# Access Compliance Report

## Public Rights-of-Way

Intersection ID: 30467	Main Street: PLANTERS_ROW_DR	Cross Street: SPRING_FROST_CT	Location: SE
ADA ID: DDBF9F5B7B1B	Ramp Type: PerpDiag	Initial Pass/Fail: Fail	Overall Compliance: No
Severity Score: 10			
Codes/Mitigation Info/Possible Solution		Field Measurements/Component Compliance

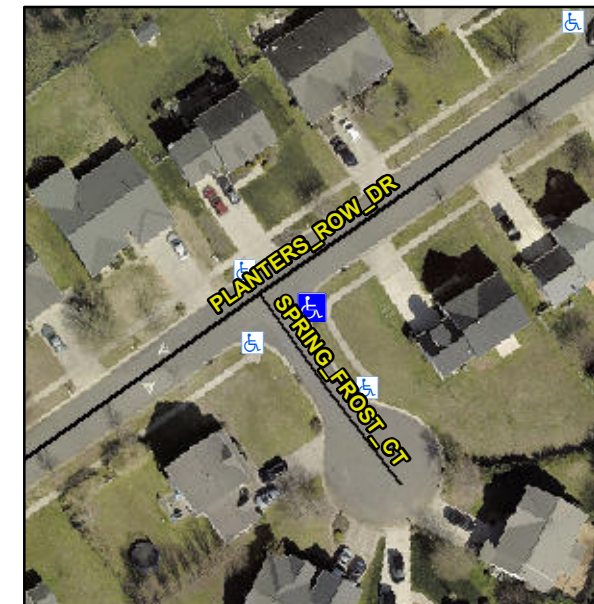
**R304.5.1, R304.5.3**

Compliance	Description	Data	Compliance	Description	Data
N/A	Ramp Length (in)	84.0	Yes	Ramp Slope (%)	5.8
No	Ramp Width (in)	46.0	No	Ramp XSlope (%)	3.4
N/A	Flare Type LT	N/A	N/A	Flare Type RT	N/A
N/A	Flare Slope LT (%)	N/A	N/A	Flare Slope RT (%)	N/A
N/A	Flare Traversable LT?	N/A	N/A	Flare Traversable RT?	N/A
N/A	Landing Length (in)	N/A	N/A	DWS Provided?	N/A
N/A	Landing Width (in)	N/A	N/A	DWS Contrast?	N/A
N/A	Landing Slope (%)	N/A	N/A	DWS Length (in)	N/A
N/A	Landing X Slope (%)	N/A	N/A	DWS Full Width?	N/A
N/A	Landing Curb? (Y/N)	N/A	N/A	DWS Offset (in)	N/A
N/A	Shared Landing?	N/A			
N/A	Gutter Ponding?	N/A	N/A	Gutter Slope (%)	N/A
N/A	Gutter Lip Ht (in)	N/A	N/A	Gutter X Slope (%)	N/A
N/A	Painted X Walk1?	No	N/A	Painted X Walk2?	No
	X Walk 1 Direction	To NW		X Walk 2 Direction	To SW
N/A	X Walk 1 Width (in)	N/A	N/A	X Walk 2 Width (in)	N/A
	X Walk 1 Slope (%)	4.6		X Walk 2 Slope (%)	6.1
	X Walk 1 X Slope (%)	5.3		X Walk 2 X Slope (%)	0.6

**Remove & Replace Curb Ramp With Two New Directional Ramps or Equivalent.**
